**METROPOLITAN GOVERNMENT OF NASHVILLE AND DAVIDSON COUNTY**

**STAFF RECOMMENDATION**

**1817/1819 Sweetbriar Avenue**

**Application:** New Construction—Infill; Show Cause

Figure 2. Infill and parking pad at 1817 & 1819 Sweetbriar Avenue.

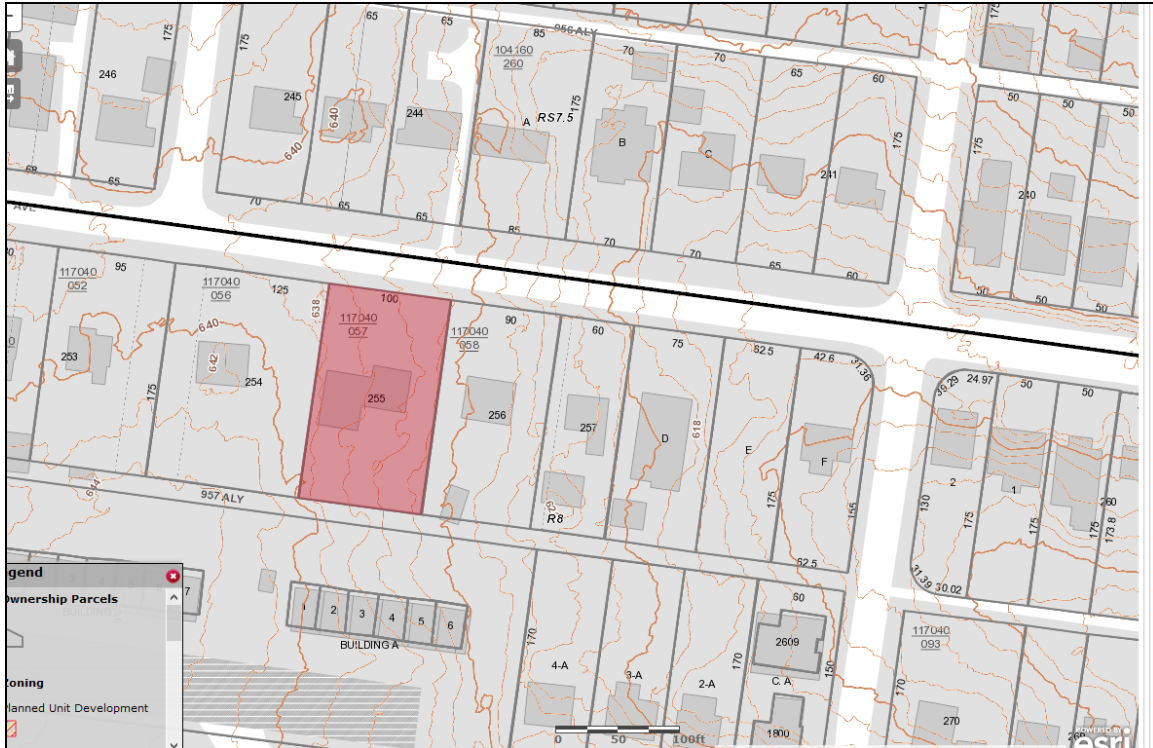
The concrete driveway, as built, stops at the front wall of the residences, has a parking pad flaring out in front of each unit and is approximately eighteen feet (18') wide. (See Figures 2 and 3.)

In this case, there is a rear alley, the project is new construction and so is not working around existing conditions, and there is no significant change to grade. Staff does not find that there are conditions unique to this site that would warrant front-yard parking pads, an overly wide driveway, or driveways that do not go to at least the midpoint of the houses.

Staff finds that the driveway width and length and the parking pads, as built, do not meet Section II.B.1.f for Orientation and is inconsistent with past decisions in like situations. Staff recommends that the front-yard parking be removed, the driveway be narrowed not to exceed twelve feet (12') in width and the driveway continued to at least the mid-point of the houses.

Correction could be a driveway to match the driveway approved as part of the permits or removing the parking pads, narrowing the driveway so it does not exceed twelve feet (12') in width and continuing the driveway at least to the midpoint of the house.

Figure 1: HCP2018-079300 and 079296.

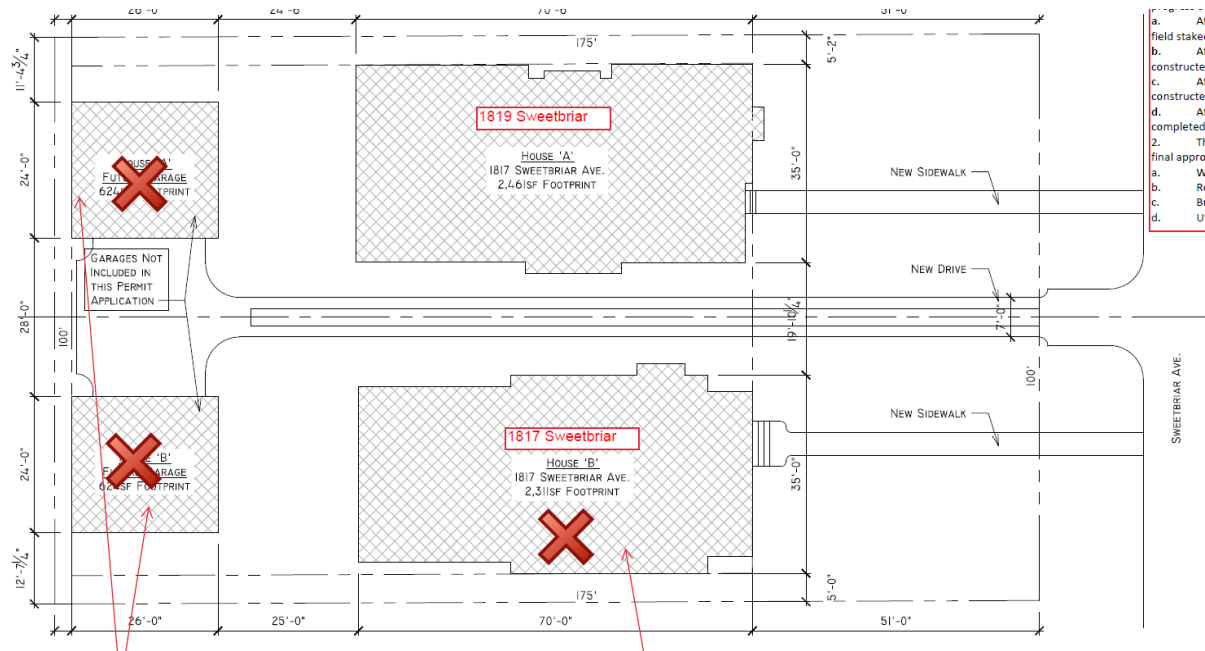
**Background:** The Commission approved the detached duplex infill at 1817 and 1819 Sweetbriar at the November 2018 MHZC meeting. Staff issued Preservation Permits 2018-079300 and 2018-079296 for 1817 and 1819 respectively. The site plan submitted for review and included in those permits showed a central shared driveway, no more than twelve-feet wide (12') wide, leading to rear garages and does not show front-yard parking pads. The site plan also included a detached accessory dwelling unit (DADU) behind each unit, but these have not yet been reviewed or permitted. (See Figure 1 and Attachments C and D.)

Correction could be a driveway to match the driveway approved as part of the permits or removing the parking pads, narrowing the driveway so it does not exceed twelve feet (12') in width and continuing the driveway at least to the midpoint of the house.
